Memo

Re: Consultation on an Application

Planning Application Ref: PL/26/0352

Address: Warren Creek, The Warren, Caversham, Reading, RG4 7TQ

Landscape Plan – Unclear Path (yellow arrows)

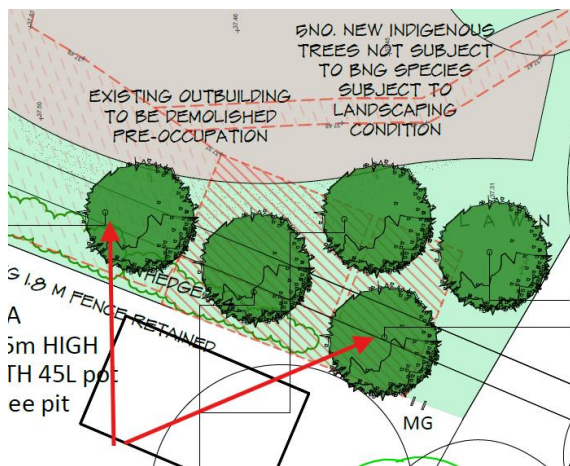
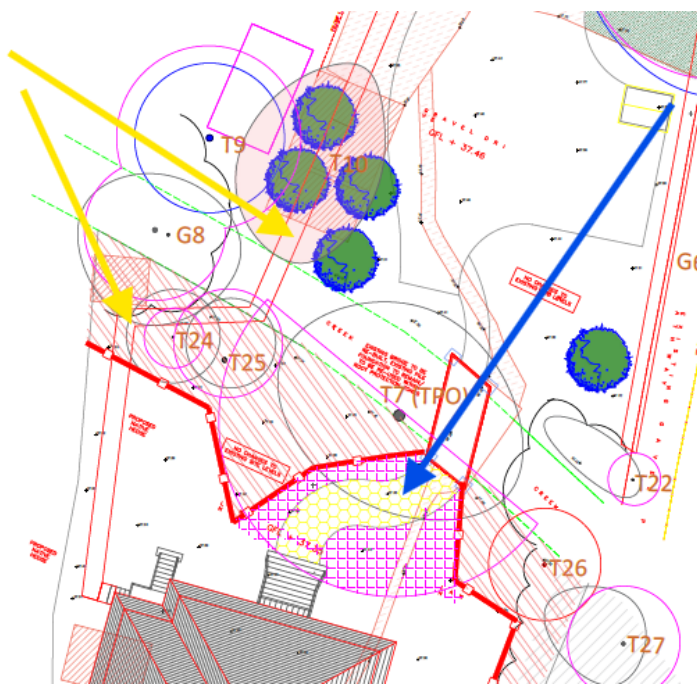
I am unclear what the lines are along the western boundary, leading from the access steps of the new dwelling, over the creek and towards the frontage. It appears to be a footpath from the new dwelling to the frontage boundary; however, this is not clear and also passes by trees and is within the CEZ of the TPP. You have advised me this is the emergency escape path; however, this is not clearly labelled and are any works required to it? There are five new trees proposed adjacent to this path, and I question whether this going to raise nuisance/safety issues in the future – some of the newly proposed trees appear to be planted in the path itself or directly adjacent to it. Section 3.11 POROUS PATH/ACCESS ROAD of the AMS, details how the no-dig porous path will be constructed, although I am not clear on what path this is - the only no-dig surfacing shown is the driveway extension, south of the bridge and within the RPA of T7 of the TPP.

Regarding paragraph 'c' of the Condition, I note five new trees are proposed which is positive. However, three of these are *Betula pendula* and two are *Ilex aquifolium*, which offers limited diversity, so I encourage a broader range of species is used. I also suggest that species choice considers the character of the site i.e. trees which can tolerate highly water saturated ground, particularly when they are proposed to be planted in close proximity to a water course. The Landscape Notes state '*Selected standard trees to be planted as shown on drawing*', but they are plotted in the emergency path, so clarity needs to be provided on this and whether this location for planting is appropriate.

This has now been omitted from the Landscape Plan. Therefore, I assume this path is not required for emergency purposes so I shall leave its omission with you to confirm acceptability.

Landscape Plans – Previous Bin Location VS Newly Proposed Bin Location

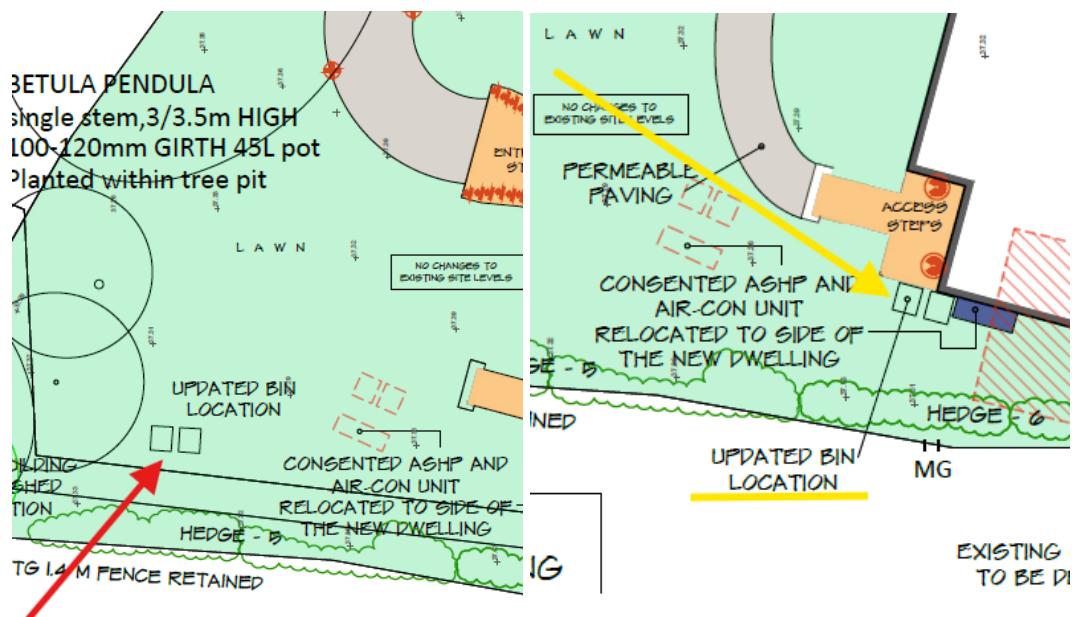
Regarding paragraph 'b' of the Condition, I note that the lighting, grass verge bollards and other small, hard landscaped objects are demonstrated which is positive. The '*updated bin location*' is in the middle of a green/lawn area so it is assumed that hard surfacing will likely be required/desired to access it; both to access it from the new dwelling and to take it to its collection point (existing bin collection point shown on the Landscape Plan). I also assume that a structure to store the bins is likely required – refuse units and other storage are required to be demonstrated. I also note that a new septic tank and connection are proposed below this path, so I assume some changes are likely which need to be demonstrated.

The latest bin storage point appears to be suitable/practical. It isn't completely clear how this will be taken to the pickup point as it is adjacent to the access steps but not connected to a path/hard surfaced area leading to the pickup point, which somewhat links to the pedestrian access in and out of the site. The CMS describes the bin store as a '*bin store location with stone base & wooden enclosure*', which clarifies a structure is required which is fine.

Landscape Plan – Hedgerows and Planting Beds within RPAs

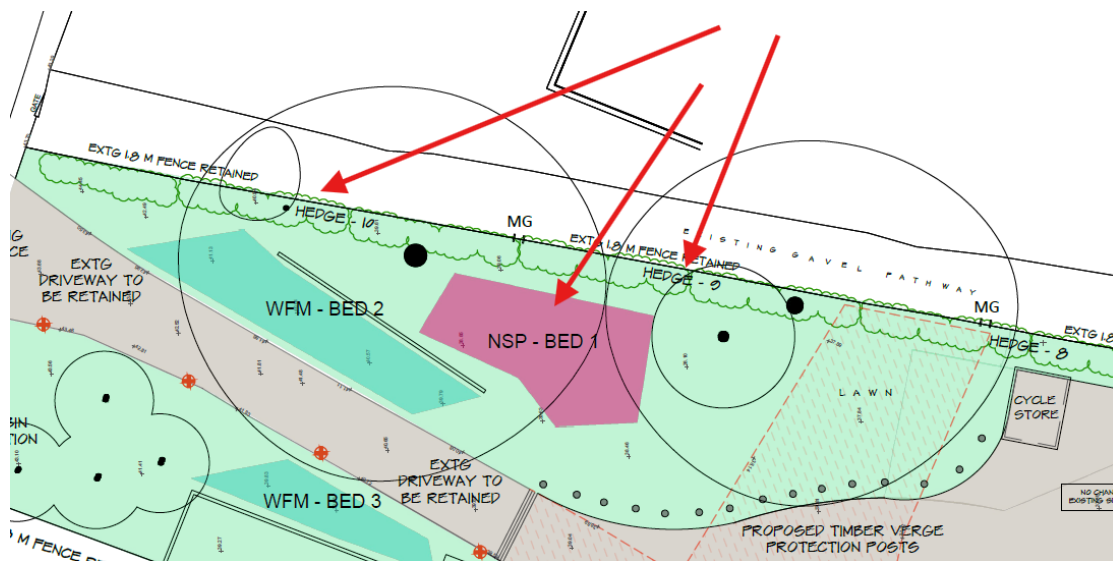
Section 2.4 Execution and Establishment of the Landscape Notes, states that for the hedgerows and planting beds '*Ground prepared to minimum 450mm depth*'. The hedgerows and planting beds are also within RPAs and very close to the base of retained trees so I am unclear how this excavation will be achieved, whilst also considering RPAs and protecting the main stem/base of the trees during excavation.

This is still the case. I note the Landscape Plan states 'Any incursions into RPA's must be by prior arrangement, following consultation with the LPA.'; however, this is not sufficient, and the extent of RPA incursions need to be demonstrated and detailed in the AMS.

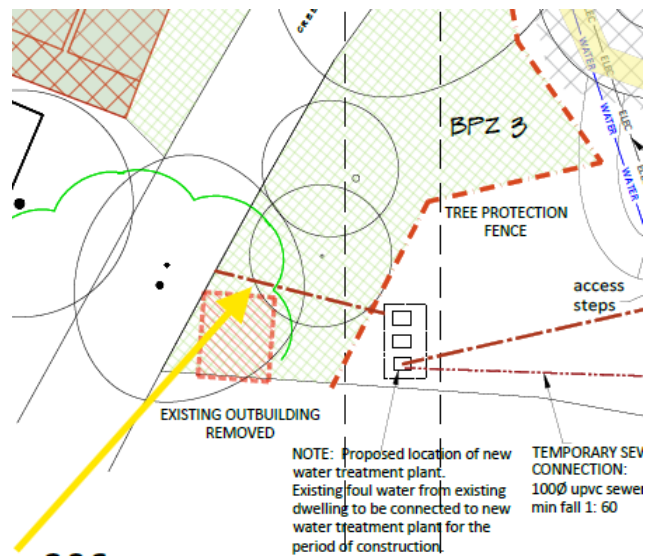
Section 2.5 Standard tree planting of the Landscape Notes, mentions excavation for planting the new trees. From assessing the TPP, it appears that one of the new trees could conflict with the RPA of T9. It is difficult to assess their true location on the TPP as their exact trunk locations aren't plotted and the tree planting in the TPP is not consistent with that in the Landscape Notes. I advise that the newly planted trees avoid RPAs and consider my comments above regarding conflict with the emergency footpath.

As above, I note this footpath has been omitted so for you to determine whether it's acceptable.

CMS - Proposed New Gate VS Approved Block Plan

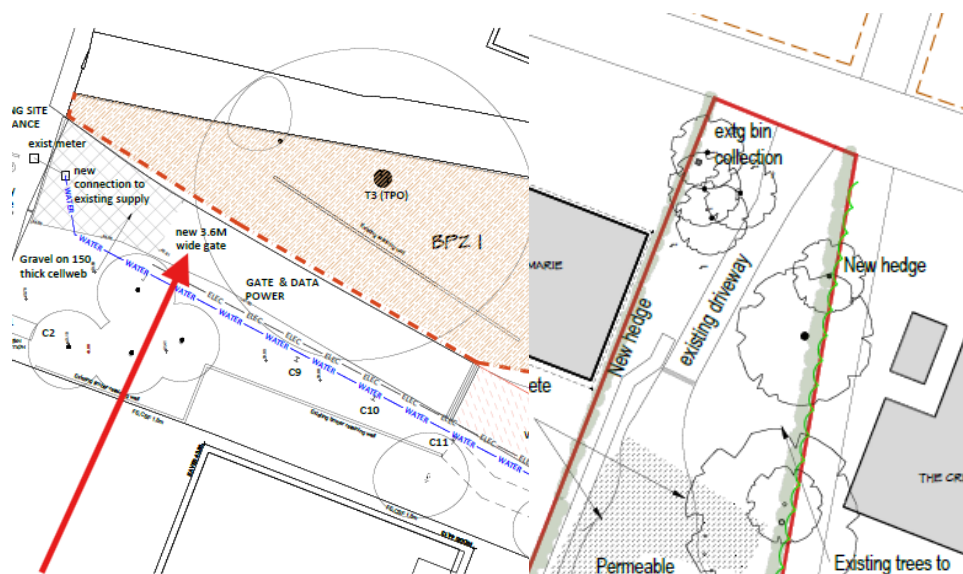
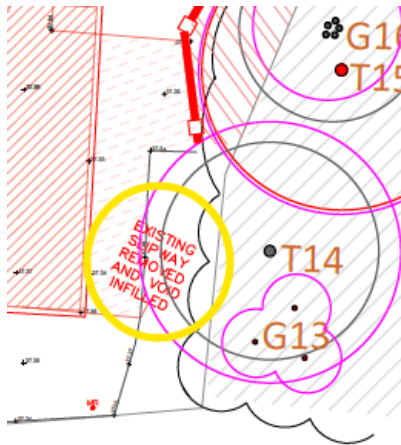
I note a 'new 3.6M wide gate' is proposed. This gate is not shown in the approved Block Plan or the current Landscape Plan, so clarity needs to be provided on this. It should also be noted this is in close proximity to T3 of the AMS and likely within it's RPA. The AMS will need to demonstrate how it will be constructed with consideration for trees. It also appears from the CMS that it is an electric gate, so it is assumed to be powered by an existing electricity route (if that is what is shown). This requires further clarification.

This has now been omitted so I have no further comment to add regarding condition requirements. I note Point 8 of the decision notice for PL/24/1614, has removed some of the PD rights from the property, including Class E (building or enclosure, swimming or other pool required for a purpose incidental to the enjoyment of the dwellinghouse). Hence a new gate (enclosure) will not be able to be constructed under PD rights without permission in the future, which is something for the applicant to consider within this application.

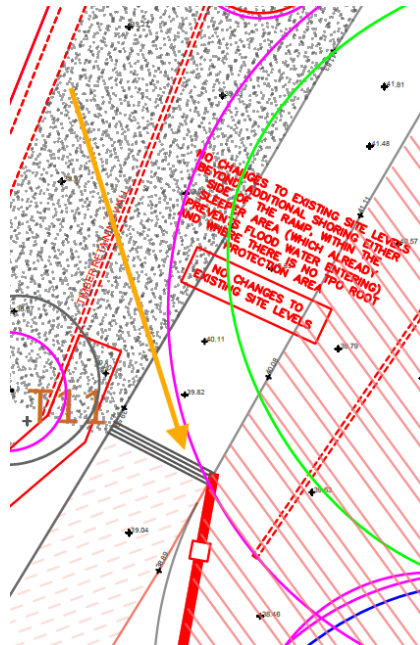
Section 2.8 TREE PROTECTION DURING BUILDING WORKS, demonstrates that all of the retained tree's rooting areas will be protected through the use of tree protection barriers and fencing. The existing concrete ground will act as ground protection throughout the build. The concrete surface at the foot of the ramp will be removed and replaced on completion of the building works, replaced with a no-dig porous surface. I am slightly unclear where this foot and ramp are located. The only RPAs that have existing concrete acting as ground protection, but is proposed to be removed, is that of T4 and T5.

So, I am unclear where this foot/ramp is positioned in respect to T4 and T5's RPAs. I have annotated an extract of the TPP below for where I assume this to be, but this is in the RPA of T3, not T4 or T5.

TPP – CEZ of T3 (no fencing or ground protection)

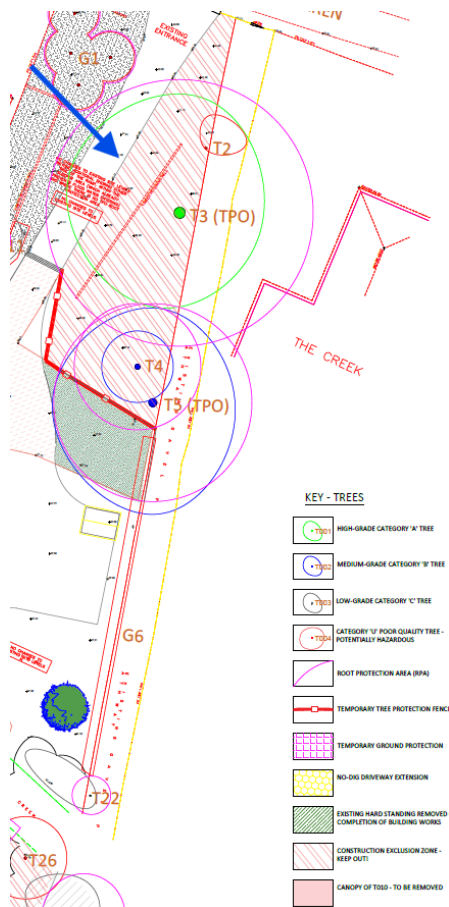
I also do not note any protective fencing adjacent to T3. It is within a CEZ which is positive, but fencing to protect the soft ground around T3 would be prudent as no ground protection is specified here either. The use of fencing would help to clearly demonstrate this is a CEZ, which is particularly important being adjacent to an 'A' category, protected tree.

Tree Protection fencing is not required along the edge of the ramp to protect the RPA of T003 as there is a steep bank along the edge of the access ramp which is marked by posts and it would not be possible or practical for vehicles or pedestrians to leave the ramp or impact on the Construction Exclusion Zone - for this reason the area was shown as Construction Exclusion Zone but not requiring to be fenced.

CMS (previous)– Loading/Unloading Area within Protective Fencing Following Existing Concrete Removal

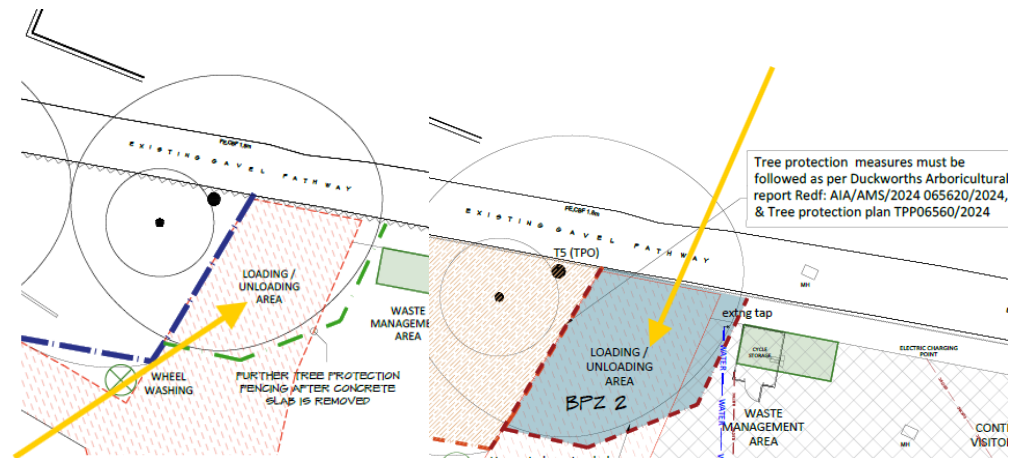
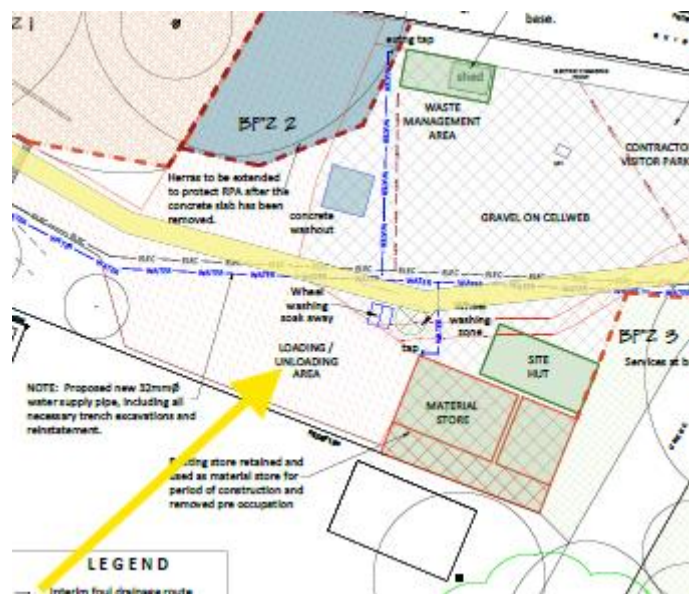
I note that the CMS has proposed the loading/unloading area for vehicles under the canopy of T5. With this in mind, is a crown lift to 4m above ground level going to allow adequate clearance for large vehicles to safely park and load/unload materials without damaging or interfering with the tree's canopy? Section 3.13 GENERAL CONSIDERATIONS, mentions transit and transverse of vehicles/plant machinery and the delivery of materials. Given that this is large development in that it is a new dwelling, I am simply questioning whether 4m of ground clearance is sufficient given the nature of the construction. The amount of materials and the associated height of the type of vehicles required to deliver this, whilst not coming into contact with the tree (T5), should be considered. If tall lorries are required to deliver the materials, will 4m ground clearance be

sufficient or would it be more appropriate to locate this loading/unloading area elsewhere. It is also unclear where this loading/unloading area will be once the existing concrete has been removed. It shows the protective fencing extended following its removal, yet this loading/unloading area is still in the same place but then conflicts with the protective fencing.

The loading/unloading area has been revised within the CMS, and I can confirm I am happy with its location.
